SITE DEVELOPMENT PLAN

9025 CHICAGO AVENUE

9025 CHICAGO AVENUE COVER SHEET

V3_site dev plan.pdf Markup Summary

DP 1.1 MVE PROJECT **61214**

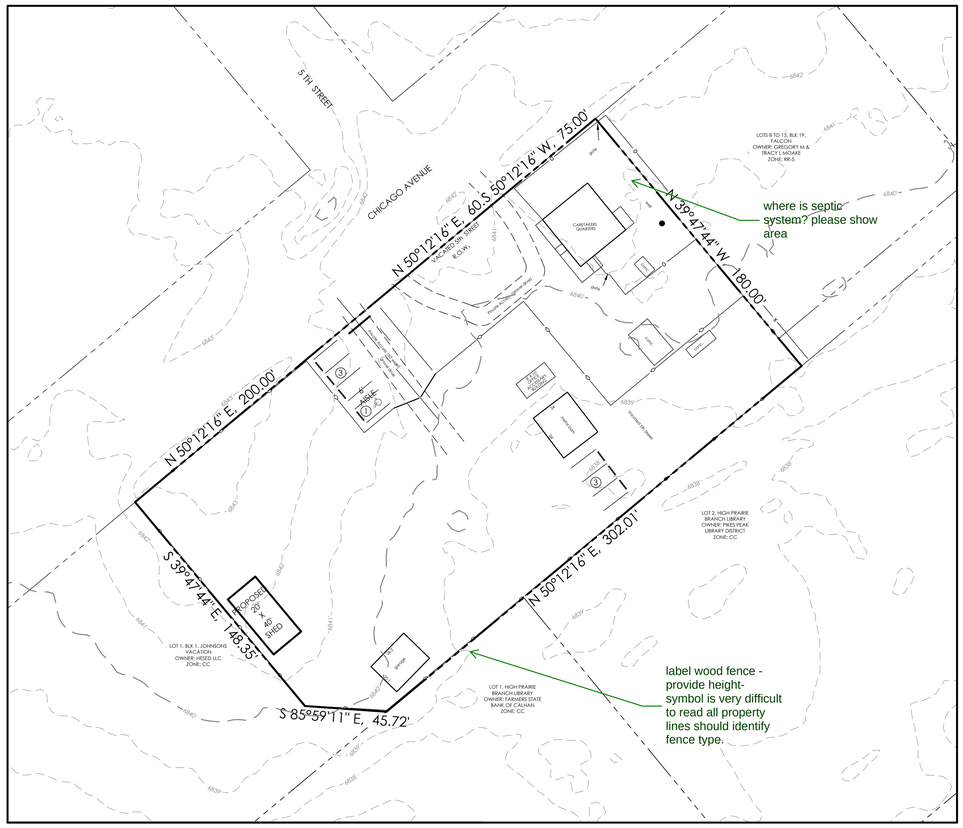
All equipment and vehicles exceeding the height of the fence shall be stored on the rear ⅓ of the property except when adjacent to a residential zoning district, in which case the equipment or vehicles shall be a minimum 50 feet from the residential zoning district boundary.

Add solar lighting will be provided for employee and customer parking.

some of the opaque fencing is painted with a landsape mural- identify which property lines the landscape fence is located

symbols are not distinguishable when on property line so please label map. Is any fencing to be removed?

Show where the 50' is

Dimension widthh of access

Add solar lighting will be provided for employee and customer parking.

Add solar lighting will be provided for employee and customer parking.

label wood fence - provide height- symbol is very difficult to read all property lines should identify fence type.

where is septic system? please show area

All equipment and vehicles exceeding the height of the fence shall be stored on the rear ⅓ of the property except when adjacent to a residential zoning district, in which case the equipment or vehicles shall be a minimum 50 feet from the residential zoning district boundary.

Add

some of the opaque fencing is painted with a landsape mural- identify which property lines the landscape fence is located

symbols are not distinguishable when on property line so please label map. Is any fencing to be removed?
